**Locality Plan - DA 2020/242**

**ASSESSMENT OF THE APPLICATION UNDER SECTION 4.15 (1) OF THE EP&A ACT 1979****4.15 (1) (a) (i) - the provisions of any environmental planning instrument****Local Environmental Plans (LEPs)**

AVANT TOWNHOMES INTRAPAC PROPERTY ARCADIA		<b>AUREUS MEDIUM DENSITY</b> 505 NORTH CREEK ROAD SKENNARS HEAD NSW 2478	
		27 NOV 2019	<b>DA 0010</b>

Figure 2 - Articulation Zone – Ground Floor

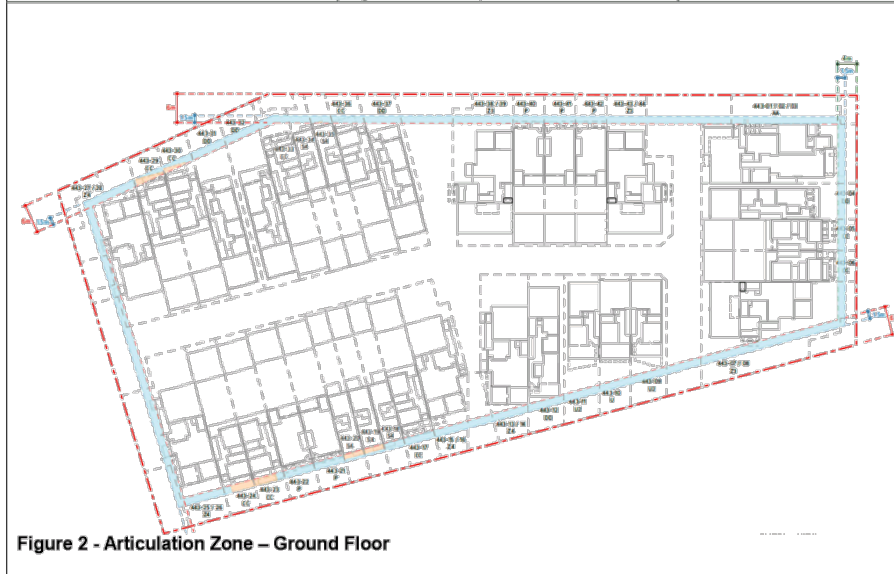
Building Envelope – 45° @ 1.8m above boundaries of public reserve to 8.5m	Minor eave encroachments allowable under clause iv.  (note: development does not have a side or rear boundary, only primary frontages and frontages to future public reserve).	Yes – allowable encroachments
<b>D. Element – Articulation Zone</b>		
Minor building elements may project forward of the building line to the primary street frontage by up to 1.5m.	Minor elements do not project beyond 1.5m	Yes
Up to 25% of articulation zone may contain building elements.	<25% encroachment into articulation zone on each street frontage – north and west (see figures below).	Yes

<p><i>Dwelling to address street and provide identifiable entrances and contribute to streetscape</i></p>	<p>All dwellings have identifiable entrances. The development will contribute to the future streetscape and provides an acceptable interface with the future adjoining local park.</p>	<p>Yes</p>
<p><b>E. Element – Building Lines</b></p>		
<p>Primary Road – 6m</p>	<p>6m setbacks to all streets (with allowable articulation zone encroachments).</p>	<p>Yes</p>
<p>Public Reserve – 6m</p>	<p>Building elements of Units 17-24 encroach into the 6m public reserve setback to the south (approved public reserve lot 442 under DA 2017/244) by up to 1.5m (note: the articulation zone only applies to the primary street frontage and not public reserves.)</p>	<p>No – The proposed encroachments into the setback to the south relate to relatively minor building elements (and are similar to that permitted within the articulation zone of a primary frontage to a road). Whilst the development has frontage to a future public reserve to the south, this area is more akin to a wide road verge (approximately 18m) than a typical public reserve (eg park area to the west). The minor encroachments will</p>

<p>not add significant bulk to the development when viewed from the public reserve or adjoining street, unreasonably overshadow this area, impact on its intended use for passive open space, landscaping and stormwater conveyance.</p> <p>The proposed non-compliance is therefore considered acceptable in this instance.</p>
<i>G. Element – Landscape &amp; Open Space</i>		
<p>Private Open Space</p> <p>Ground level courtyard = minimum 40m<sup>2</sup>, 4m minimum width and maximum gradient of 1:10.</p> <p>No ground floor entries = balconies with minimum area of 25m<sup>2</sup> and a minimum width of 2.5m.</p> <p>Private open space accessible from a living area.</p> <p>Where practicable, private open space is to be located to the north or east of the dwelling and is required to have appropriate orientation and provisions to allow for winter sun and summer Shade.</p>	<p><u>Unit 01</u></p> <ul style="list-style-type: none"> <li>• Ground floor entry but primarily upper level unit.</li> <li>• Ground floor courtyard 27m<sup>2</sup> and 5m wide (not adjacent to living areas)</li> <li>• Balcony off living area = 10m<sup>2</sup> and 2.5m wide (north facing).</li> <li>• Balcony off living area = 13m<sup>2</sup> and 2.5m wide (east facing).</li> <li>• Unit also has rooftop courtyard = 20m<sup>2</sup></li> </ul> <p><u>Unit 02</u></p> <ul style="list-style-type: none"> <li>• Ground floor entry but primarily upper level unit.</li> <li>• Northern balcony off living area = 18m<sup>2</sup> and 2.8m wide (north facing).</li> <li>• Unit also has rooftop courtyard = 19m<sup>2</sup></li> </ul> <p><u>Unit 03</u></p> <ul style="list-style-type: none"> <li>• Courtyard = &gt;40m<sup>2</sup>, &gt;4m wide and flat (east facing).</li> <li>• Courtyard off bedroom (north facing) = 36m<sup>2</sup> and 5m wide.</li> </ul> <p><u>Unit 04</u></p> <ul style="list-style-type: none"> <li>• Courtyard off Ground floor bedroom = &gt;40m<sup>2</sup>, &gt;4m wide and flat.</li> <li>• Balcony off living area = 23m<sup>2</sup> and 4.2m wide (east facing).</li> </ul>	<p>No – Variations acceptable.</p> <p>Whilst not all dwellings strictly comply with each element of the private open space controls, the combination of the spaces provided (courtyards, balconies and rooftop terraces) is deemed to be sufficient to meet the recreational and service needs of the future residents of the development.</p> <p>The level and design of private open space for the development is therefore acceptable.</p>

**Landscaping and open space**

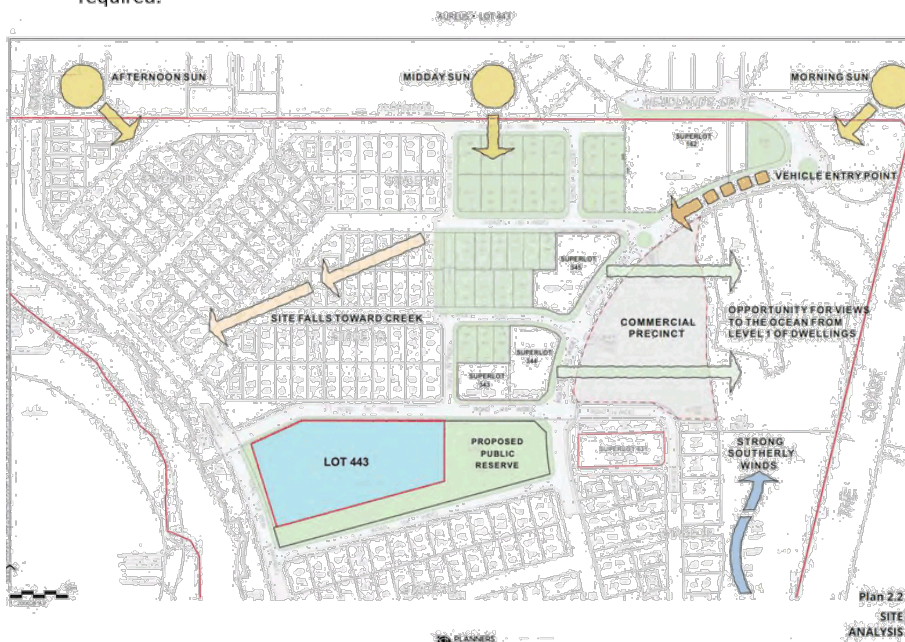
- The minimum planning requirement is 90sqm per dwelling
- Once all infrastructure is considered (i.e. car spaces, floor area dwellings, roads, 3 infiltration trenches, pathways) the total landscape area provided is 3210sqm which equates to 72.5sqm per dwelling.

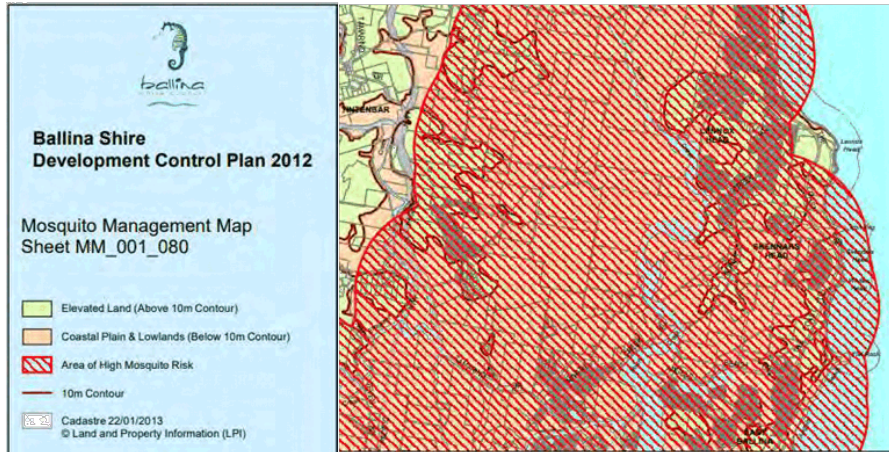
Lot 443 is within an area of high mosquito risk as per Ballina Council's Mosquito Management Plan (map).

No compliance data with BDCP12 3.6.3 is contained in the DA in reference to:

- iv. bullet point 2: any development that includes stormwater control ponds or water features designed or capable of holding water for a period in excess of 48hrs requires:
  - Minimum buffer 100m wide
  - An entomological report
- vi. Entomological report to include bullet points 1 – 4 to be addressed
- vii. Was an entomologist assessment carried out at DA site at rezoning stage?
